TO: HONORABLE CHAIRMAN AND PLANNING COMMISSION
FROM: RON WHISENAND, COMMUNITY DEVELOPMENT DIRECTOR
SUBJECT: TENTATIVE PARCEL MAP PR 04-0189, AT 319 4th STREET
(APPLICANT: MARQUEZ)
DATE: JANUARY 9, 2007

Needs: For the Planning Commission to consider a Parcel Map application filed by Twin Cities Surveying on behalf of Jose & Maria Marquez, to subdivide an approximate 1-acre parcel into three parcels.

A RESOLUTION OF THE PLANNING COMMISSION
OF THE CITY OF EL PASO DE ROBLES
TO GRANT TENTATIVE MAP APPROVAL FOR
PARCEL MAP PR 04-0189
(MARQUEZ)
APN: 009-241-004

EXISTING RESIDENCE WITH NEW CARPORT
 1" = 8"

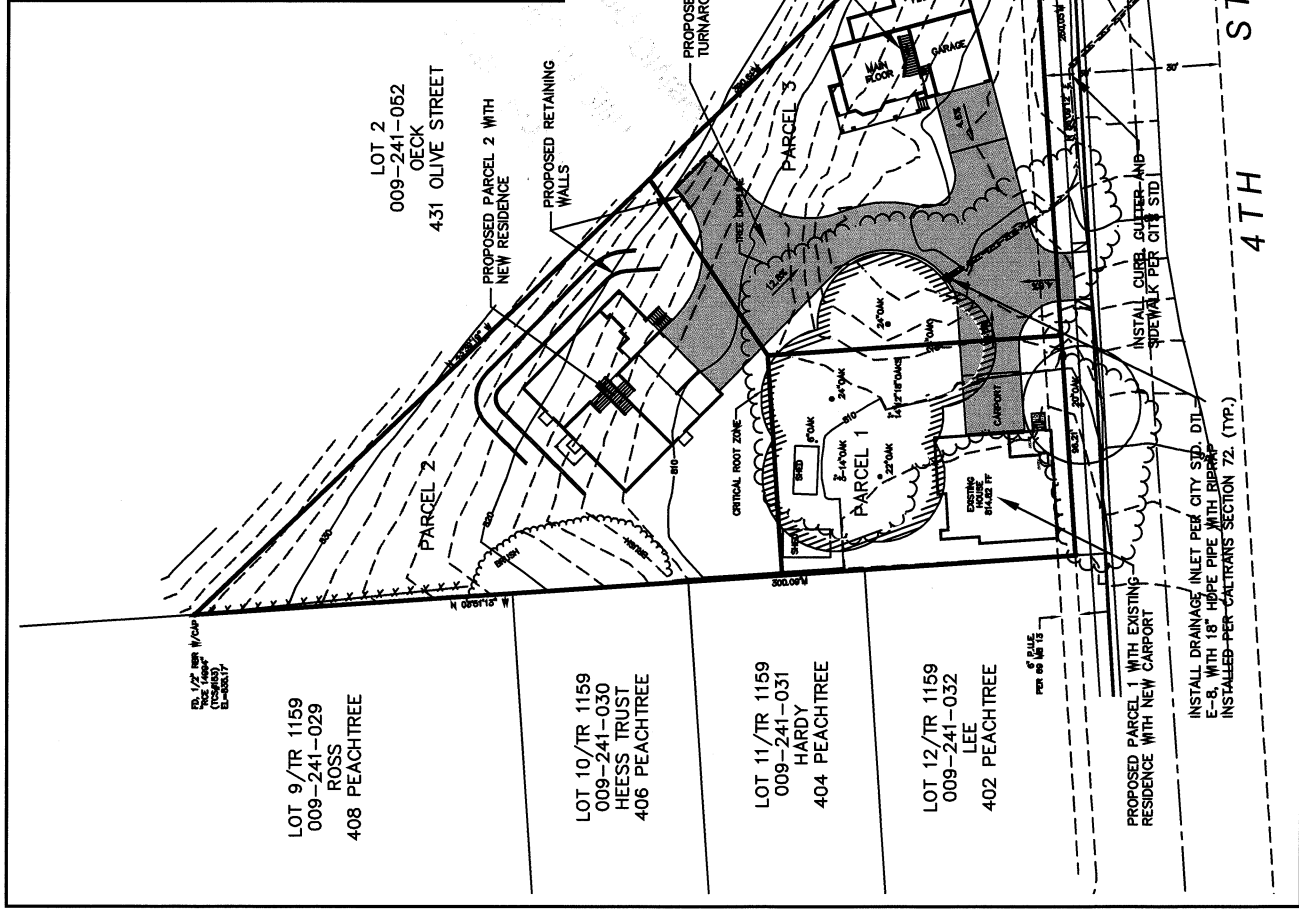
6. Prior to the recordation of the Parcel Map, the carport as shown on Exhibits B-2 & E-2 shall be installed, along with the paved driveway. Note: a temporary paved driveway may be necessary until the final shared driveway that will access parcel 2 and 3 is constructed.

Arborist Report
 Tree location Map

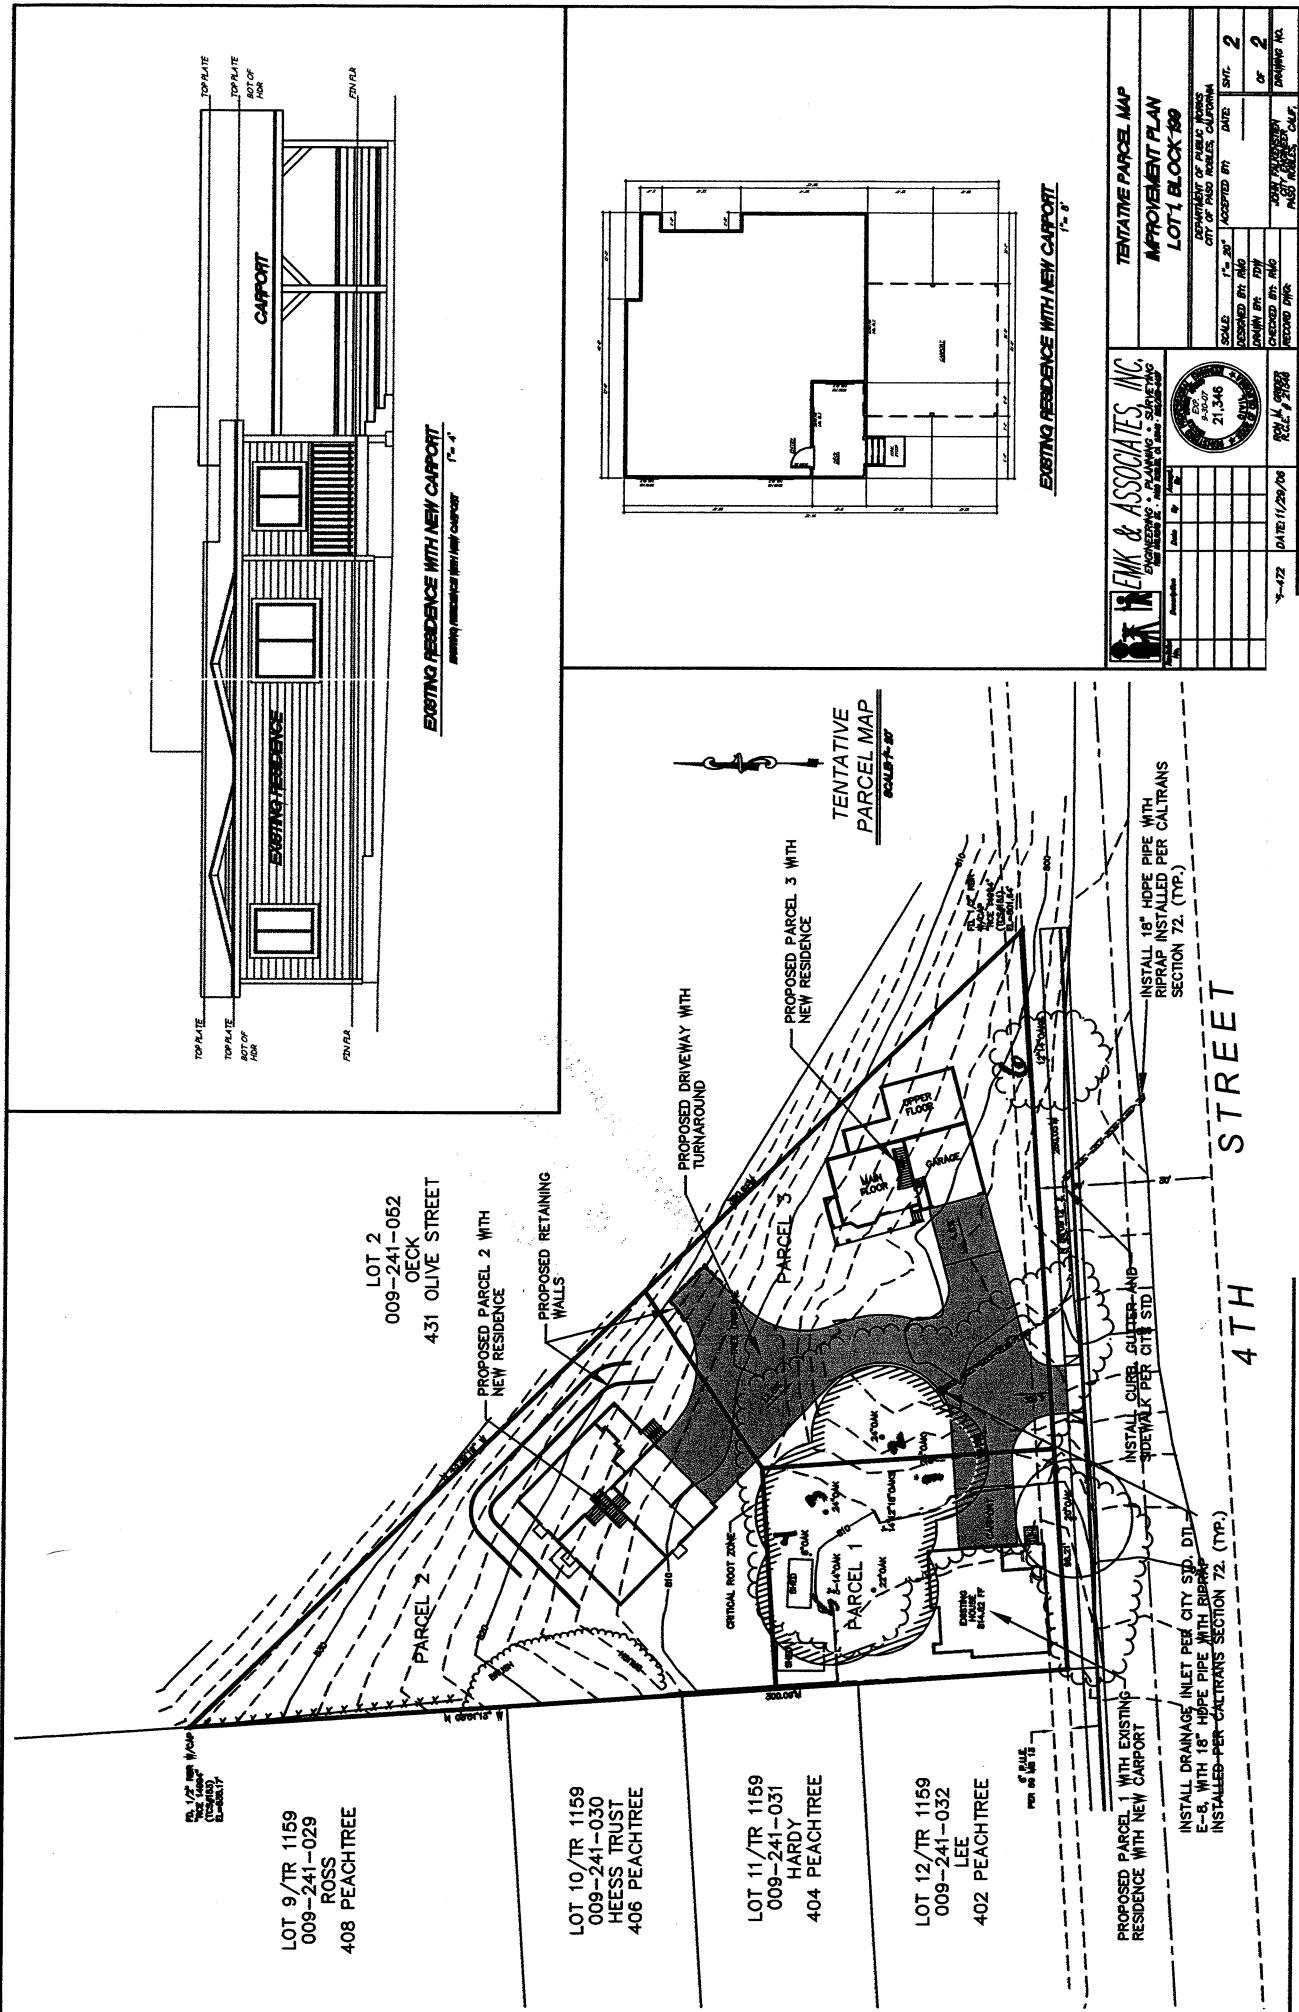
Specific Mitigations to this Project: As stated above, shift the building envelope (proposed parcel 2) ten feet north and follow the building plan descriptions. All applicable mitigation measures described below shall be followed.
